**ATTACHMENT 2A**

**Emergency Plan Marked-up Pages – Byron Station**

Exelon Standardized Emergency Plan EP-AA-1000  
and  
Emergency Plan Annex EP-AA-1002

# **EXELON NUCLEAR**

Figure B-1a: Exelon Overall ERO Command Structure

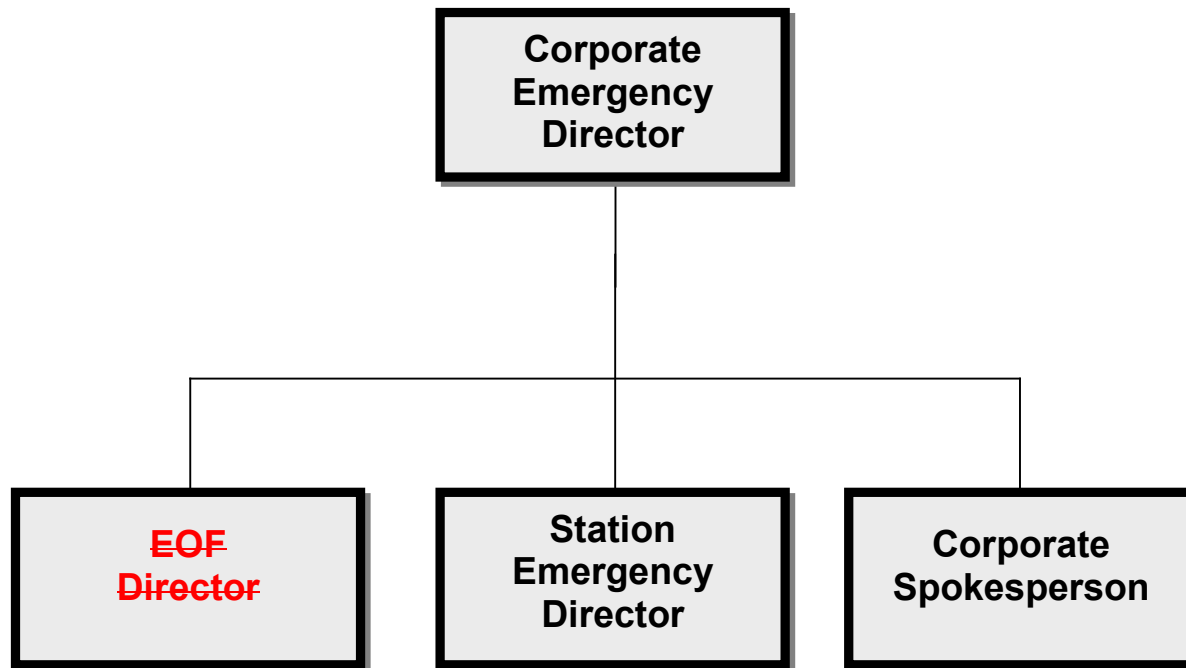
ERO staffing tables contained ~~within the station specific Annexin Appendix 5~~, lists the key positions of the ERO ~~and the supporting positions assigned to interface with federal, state, and county authorities~~. Figures B-1a through B-1d illustrates the overall emergency response organization. Section B.5 discusses specific responsibilities and the interrelationships for key positions.

**Figure F-3: NRC Communications for Nuclear Response**

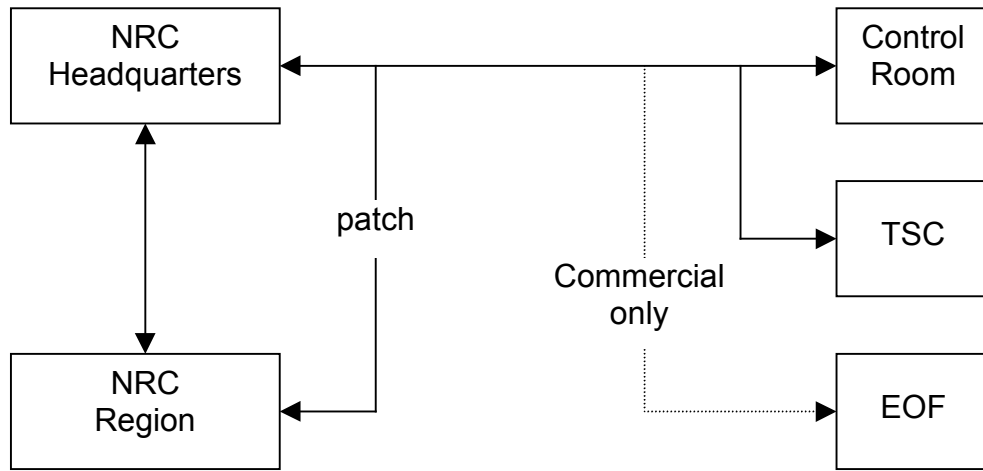
~~Health Physics Network (HPN): There also exists a separate dedicated telephone between the NRC, the TSC, and EOF for conveying health physics information to the NRC as requested or as an open line.~~
